Product Change Notification

Change Notification #: 109370 - 02
Change Title: Intel(R) Server Board S5520UR, PCN 109370-02, Product Design, System Software Updates, Heatsink TIM, and Resistor Value changes, Reason for Revision: Addition of load plate change
Date of Publication: June 30, 2009

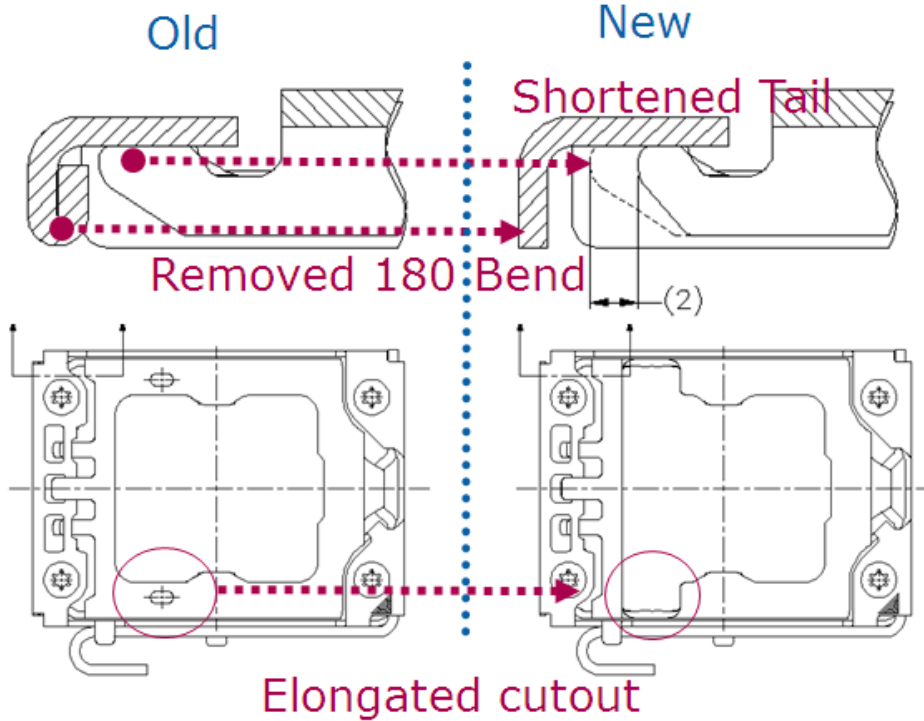
Change 4) Intel is changing the pressure plate used on the processor sockets to a different version. This will accommodate future socket designs. For details see the pictures below. There is no change to the fit, function, or operation of the processor socket.
